NORTHEAST TRI-COUNTY HEALTH DISTRICT
Division of Environmental Health
☒ Colville Office, Box 270, Phone 684-2262
☐ Newport Office, Box 490, Phone 447-3131
☐ Republic Office, Box 584, Phone 775-3161

Permit No. c 7876

**NORTHEAST TRI-COUNTY HEALTH DISTRICT
SEWAGE DISPOSAL SYSTEM PERMIT APPLICATION**

Ad Built
10/22/93 EAM

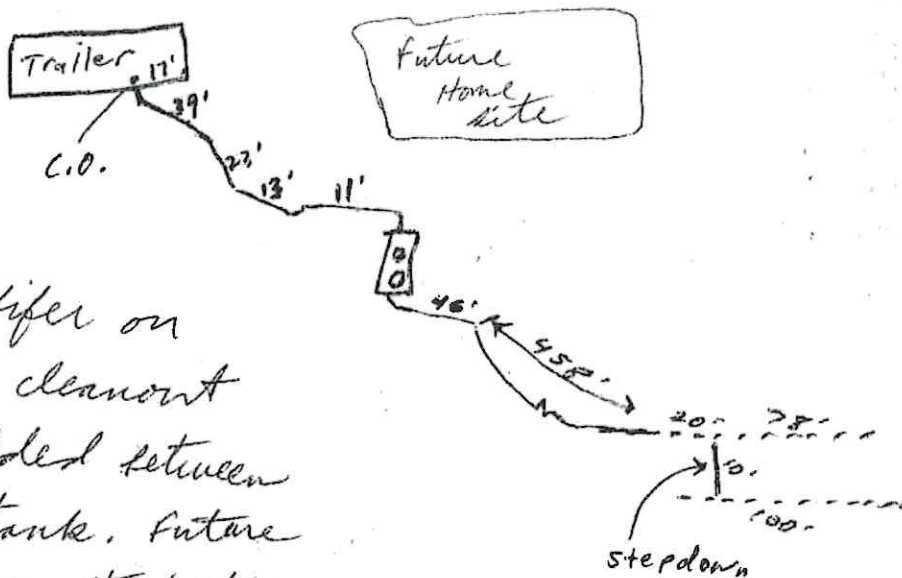
Told Larry fifer on site that a cleanout should be added between trailer and tank. Future home will have straight shot into tank.

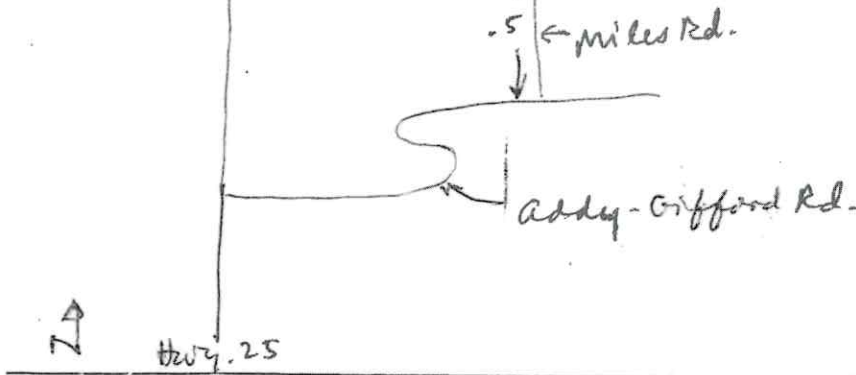
Comments: 6/10/93 - Extensive rock outcroppings & shallow bedrock in applicant's originally-proposed d.f. area. Can do 12" max. depth trenches in that area (between test holes 1 & 2) w/ 1 1/2 - 2' native soil.

As Built
 10/22/93 EAM

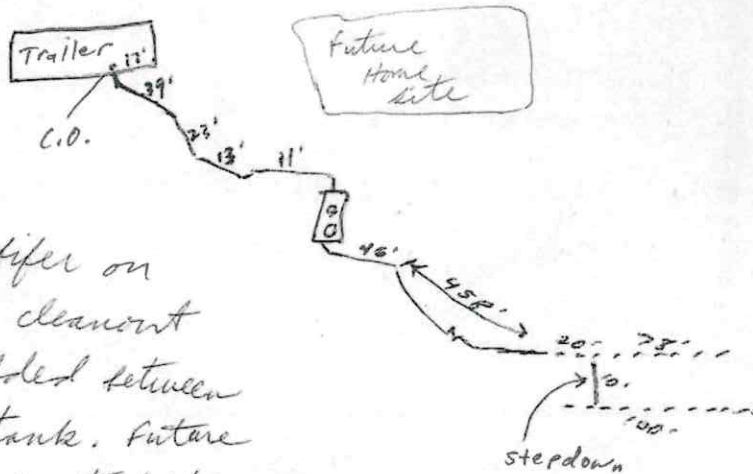
Told Larry fifer on site that a cleanout should be added between trailer and tank. Future home will have straight shot into tank.
